Sincere gratitude is extended to the reviewer for her/his careful review of the manuscript. Those comments are all valuable and very helpful for revising and improving our paper, as well as the important guiding significance to our researches. Here are our responses to the reviewers' comments.

Specific comments:

Fig. 1. Location of hydrological and meteorological stations in the Jinghe River

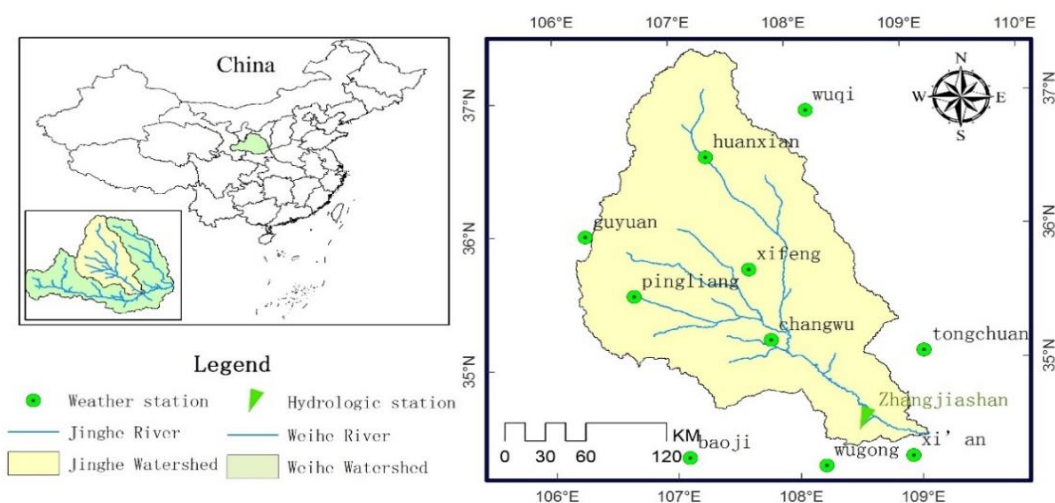
(16) Line 13: It is better to merge Figure 1 and Figure 2, since they give the similar information.

Response: We have merged Figure 1 and Figure 2 in the revised manuscript.

Fig.2 The abrupt change points of precipitation and runoff in JRB with Sequential cluster

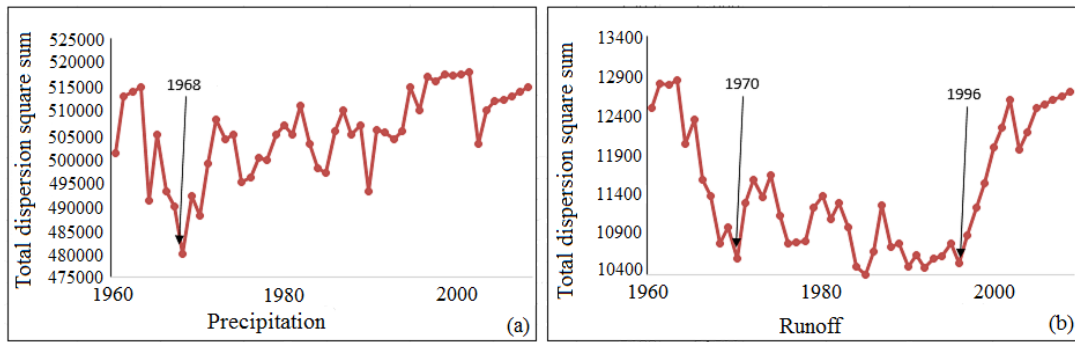
(31) Page 13 Lines 14-15: Why did the authors select the period of 1960-1970 as the baseline period?

Response: By means of sequential cluster analysis method, we have obtained the break points of precipitation and streamflow in Jinghe River. The break points appeared in 1970s, so we selected the period of 1960-1970 as the baseline period. We have put the investigation results into the manuscript. The break points of precipitation and streamflow are as follows:

Fig.3. Changes of annual streamflow and precipitation of JRB

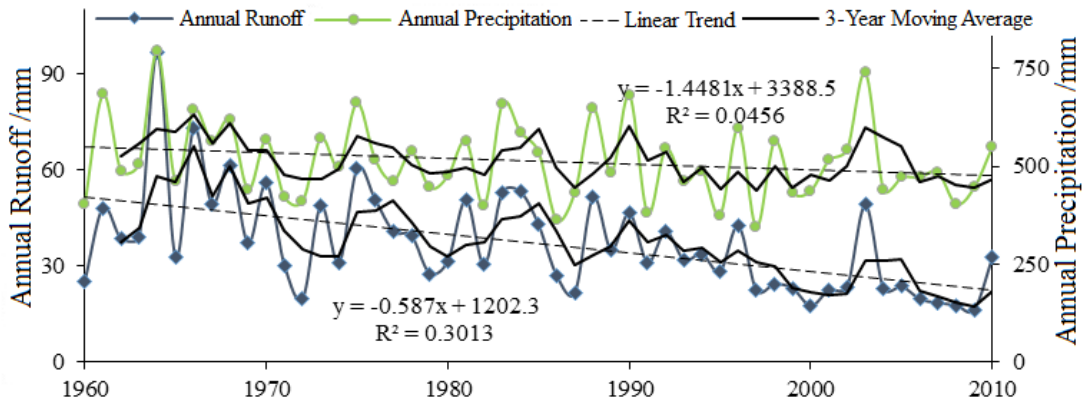
(27) Lines 21-24: The author concluded that the streamflow had a larger decrease than precipitation, but why the regression slope of precipitation was larger than that of streamflow?

Response: According to the comment, we have checked the Fig.2. It was a double-coordinate line chart, and the units were different, so the regression slope of the precipitation and runoff were not comparable.

Fig.5. (a) Elevation maps of the study area at 40 m resolution. (b) Grid of VIC model. (c) Sub-basin of TOPMODEL

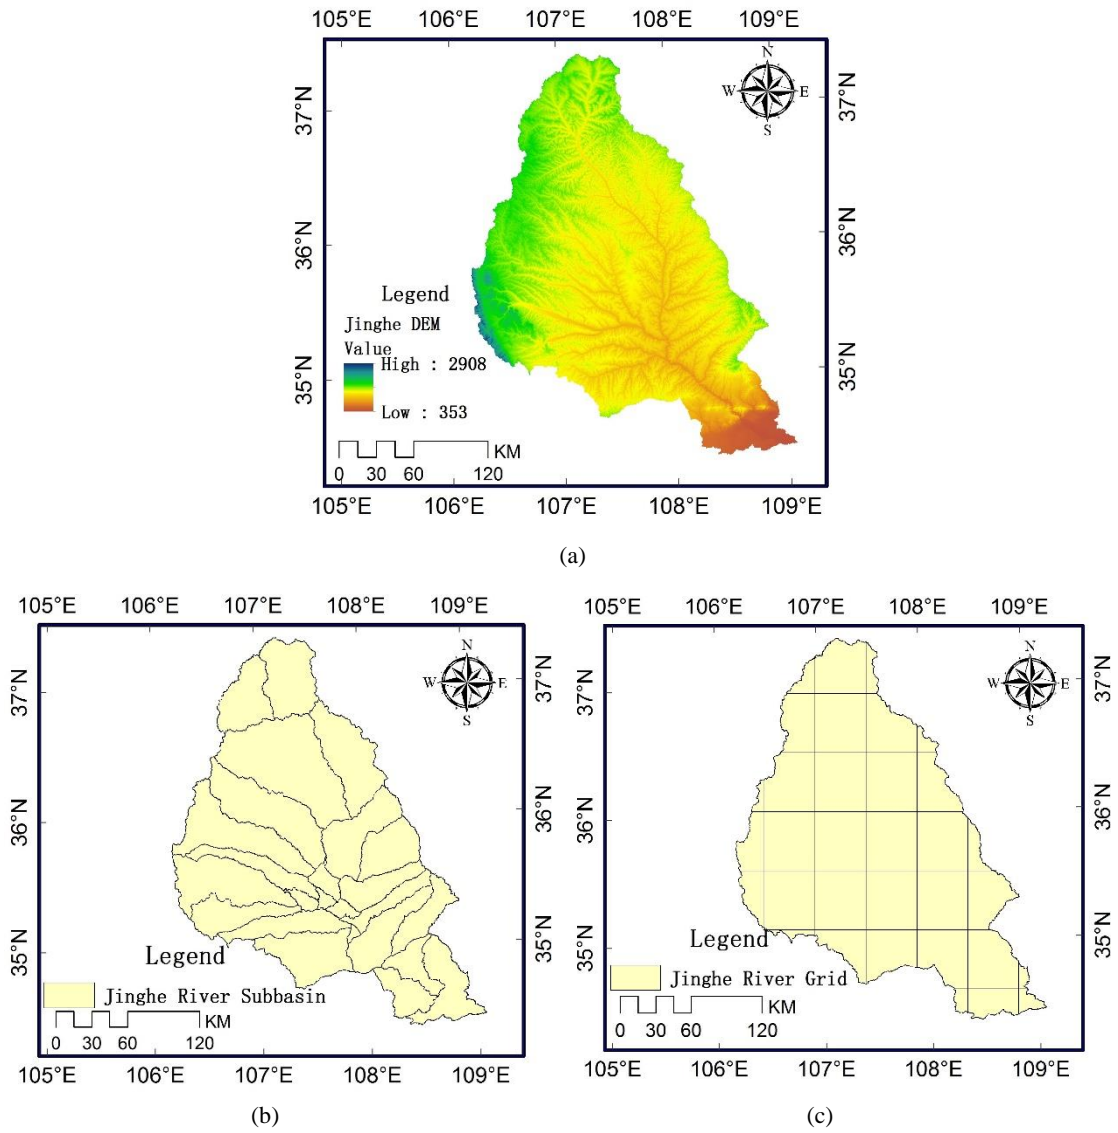
(40) Figures: Please adjust the font sizes in all figures. The font sizes in Figures. 5-9 are too small. It harms the quality of presentation.

Response: Corrected.
